Westinghouse
Electric Corporation

Commercial Nuclear
Fuel Division

RE-EKR-94-004
From CNFD-Columbia
AN 426-3247
Date March 25, 1994
Subject SITE EMERGENCY PLAN REVISION

MARCH 25, 1994 SEP REVISION

FIGURE 1

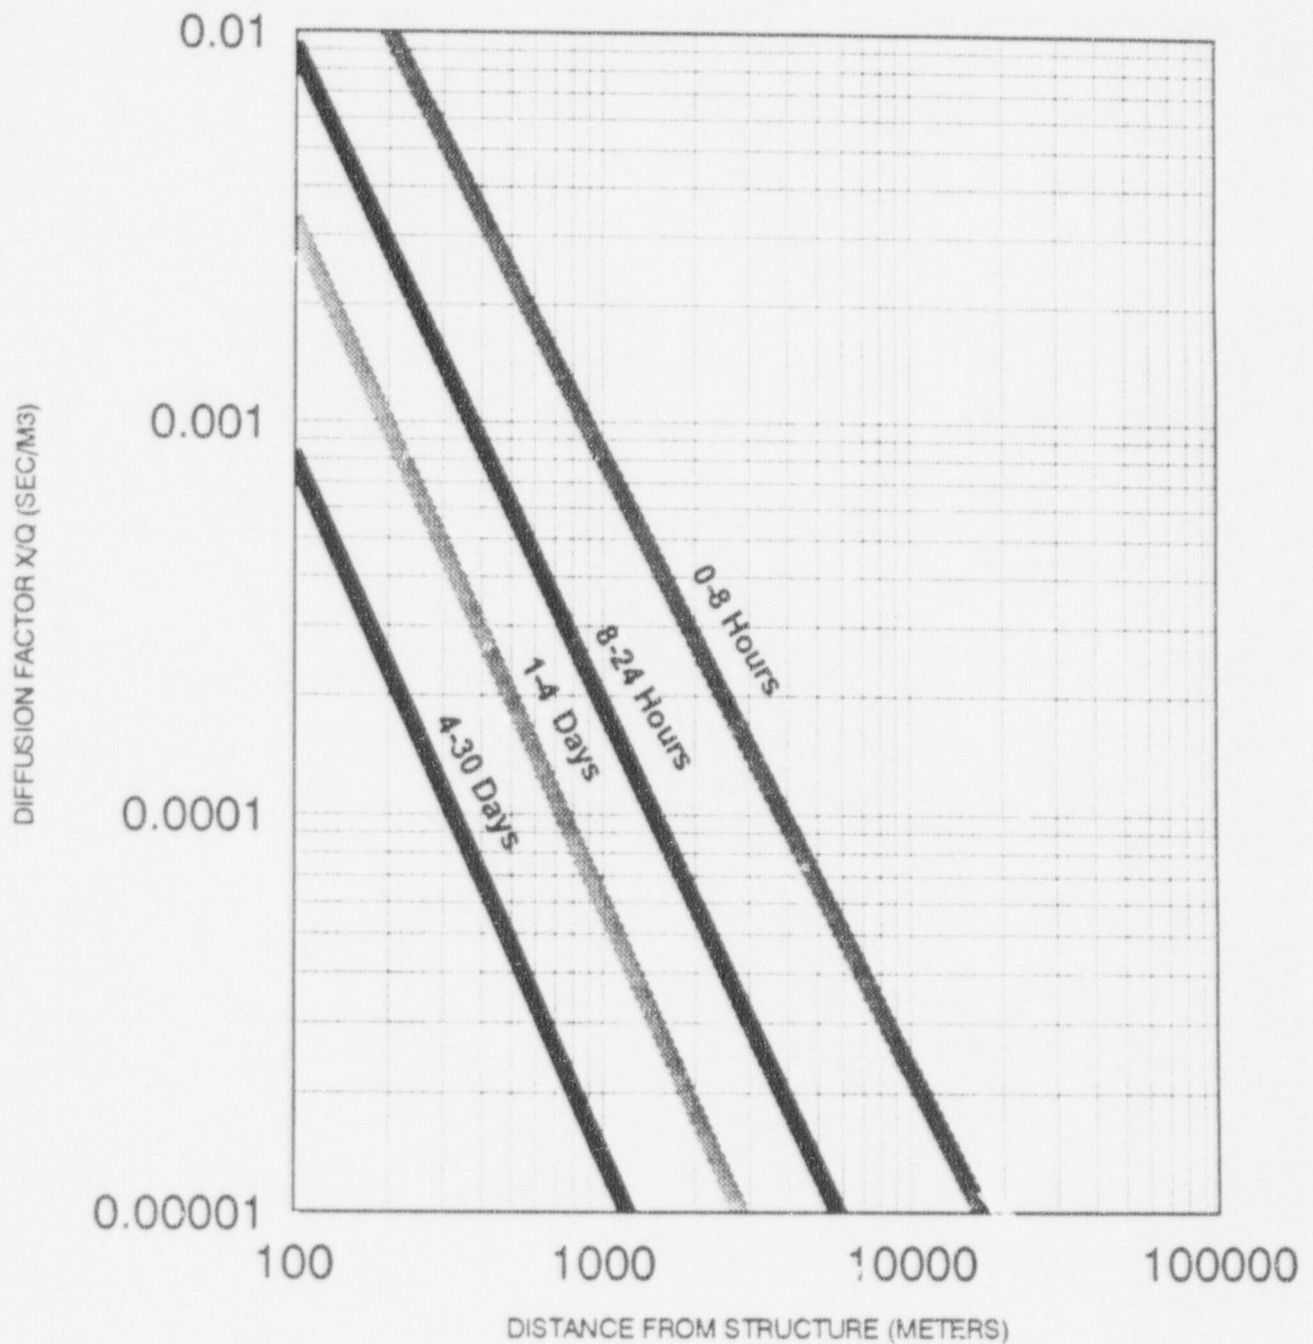
- Revised to incorporate Emergency Brigade level criteria.
12. CSEP-0017-A
- Revised Figures 1 and 2 to clarify graphs.
13. CSEP-0019
- Revised 7.0.5 to add Emergency Classification Logic Flow diagrams as CSEP-0019-6, CSEP-0019-7 and CSEP-0019-8.
